SERVICE DIRECTIVE BULLETIN NO. 0113

1. SUBJECT: Cyclic Trim Actuator Switch Assembly Inspection
2. MODEL: F-28A, 280, F-28C, 280C, F-28F, 280F, and 280FX
3. EFFECTIVITY: S/N 828 and prior; S/N 2133 and prior
4. BACKGROUND:

Figure 1. Properly Installed Screws – The heads of the inner screws face the spring capsule.

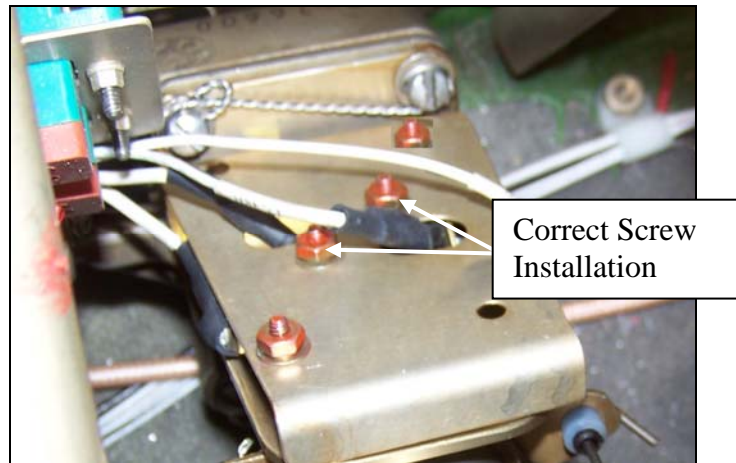
- 6.1 Locate the trim actuator assemblies by removing the seat deck.
- 6.2 Inspect the lateral and longitudinal trim switch assemblies for the proper screw orientation. The screw shanks and nuts should be visible on the wiring side of the switch assembly (*Figure 1 and Figure 2*). The heads of inner screws should be facing the spring capsule.

6.3 If the screws are installed properly, no additional inspection is required. Re-install the seat deck.

Figure 2. Improperly Installed Screws (a) (b) – The shanks of the inner screws face the spring capsule (b). (The trim actuator is removed from the aircraft.)

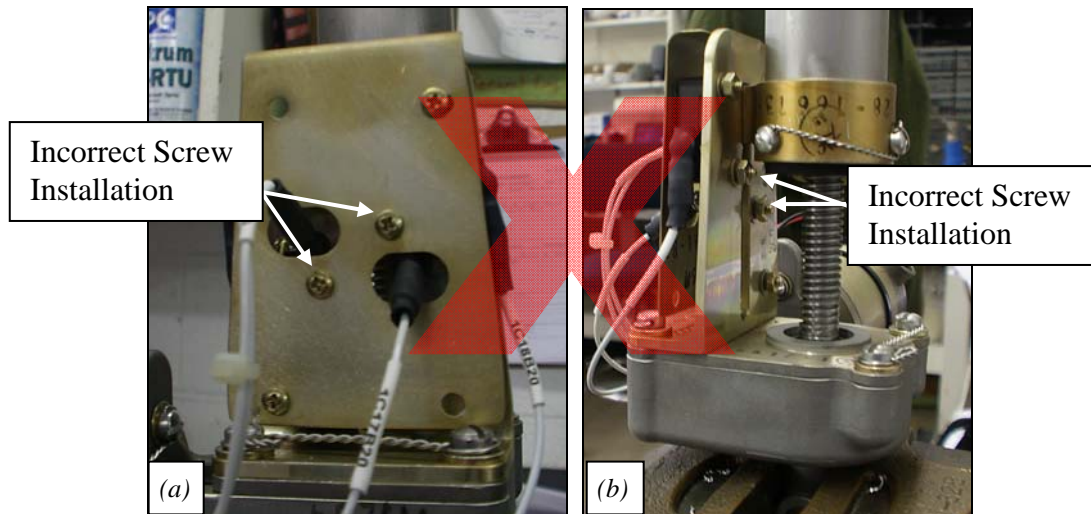
Enstrom has received a report of an incorrectly assembled trim actuator switch assembly used in the cyclic trim system. The screws that assemble the switches to the bracket were inadvertently installed in the opposite direction. This is a concern for the screws adjacent to the bracket slot, as the protruding shanks could interfere with the spring capsule travel and possibly compromise the performance of the cyclic trim system.

6.4 If the screws are not installed properly, proceed to paragraph 6.5.

- 6.8 Remove the inner screws (3), washers (4) (5), and nuts (6) from the switch assembly. Re-install the inner screws (3), washers (4) (5), and nuts (6) such that the screw heads face the spring capsule. Use care to avoid moving the position of the switches when installing the screws.

Figure 3. Cyclic Trim Switch Assembly

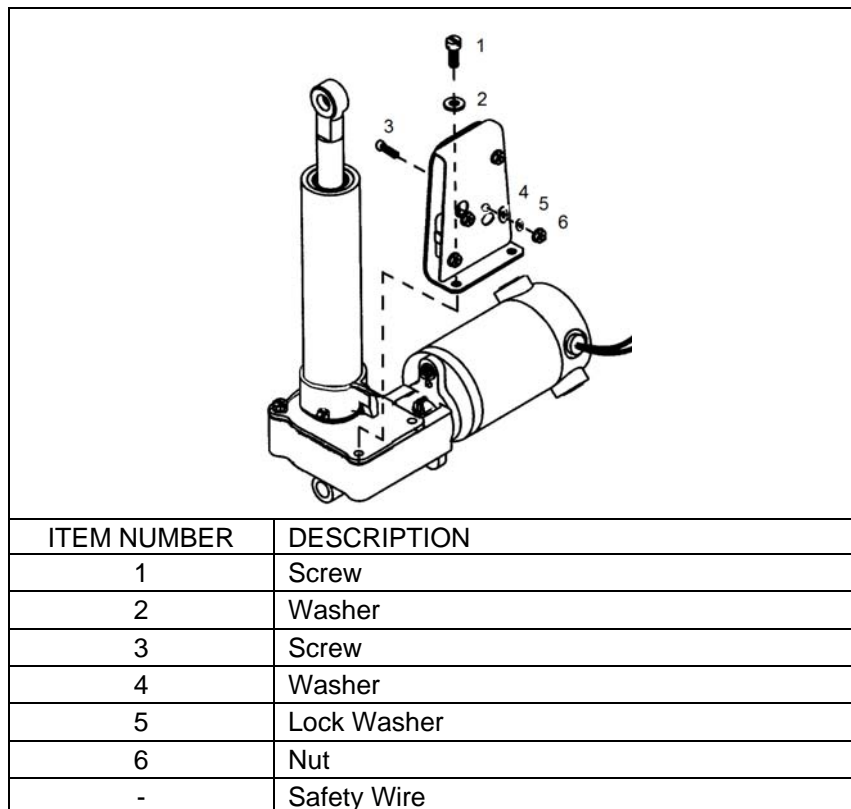
- 6.7 Remove the safety wire, screws (1) and washers (2) attaching the switch assembly to the trim actuator. Remove the switch assembly (*Figure 3*).

- 6.9 Re-install the switch assembly to the trim actuator assembly with the hardware removed in step 6.7 and safety wire.
- 6.10 Check the spring housing travel. Refer to SDB 0110 Rev. 3, or latest revision, for instructions on checking the travel and making required adjustments.
